6/9/11

YLW – Potential Revisions

Town Center District Zone

Figure 1. 20.92.020

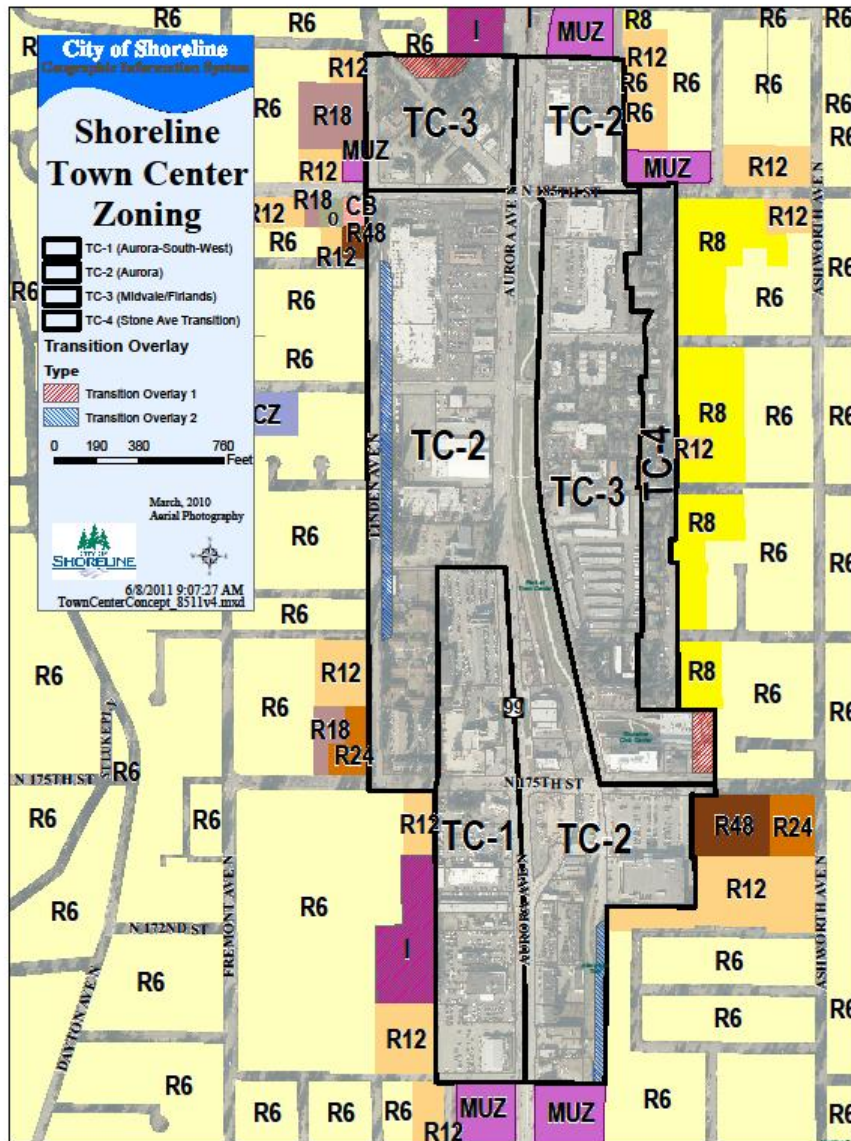
Comment [p5]: SE Corner -Transition Overlay 2 needs to be adjusted west off SCL.

Comment [p6]: New Map with Transition Overlays 1 and 2

20.92.030 Street Types and Pedestrian Circulation.

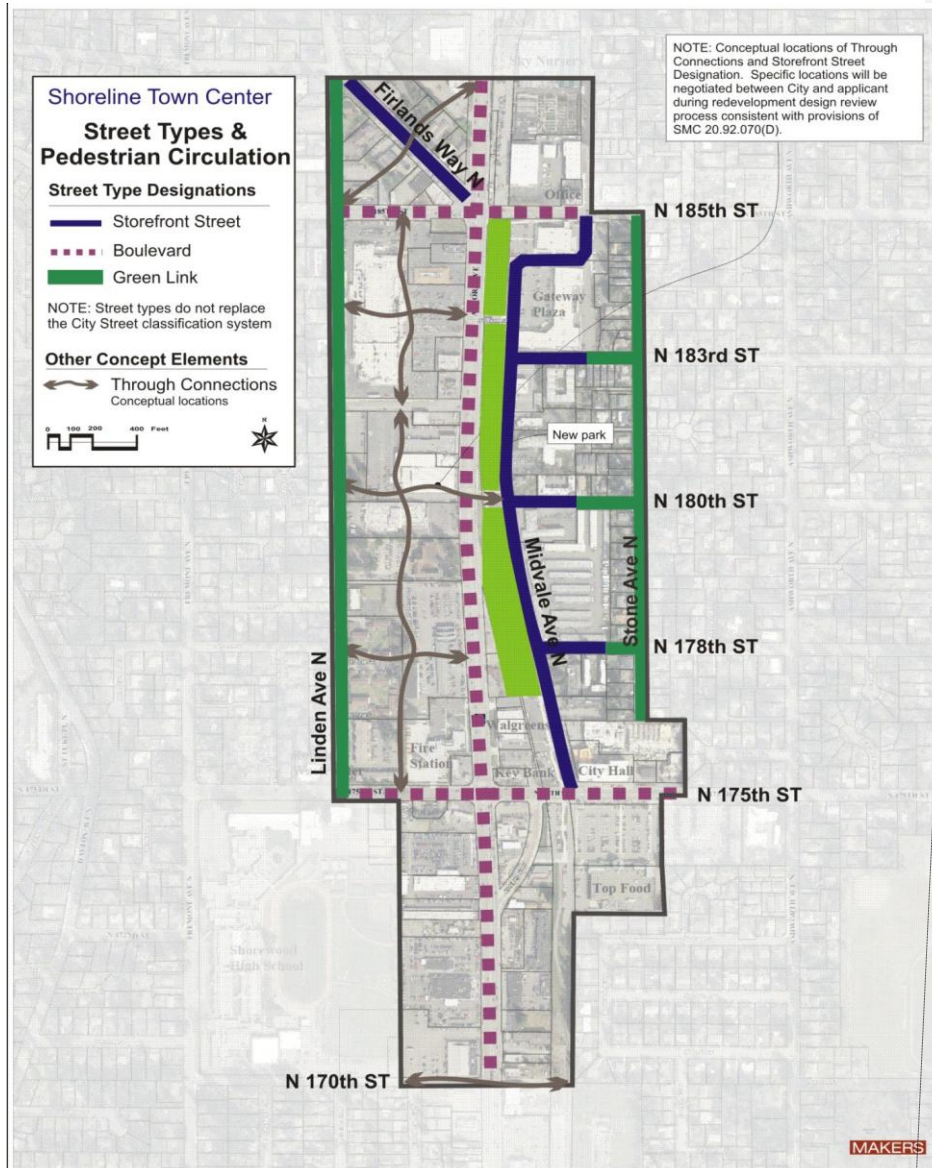
Comment [p14]: Will be revised to extend Storefront Streets to Stone Avenue. Mid-block street abutment of two different street sections do not work.
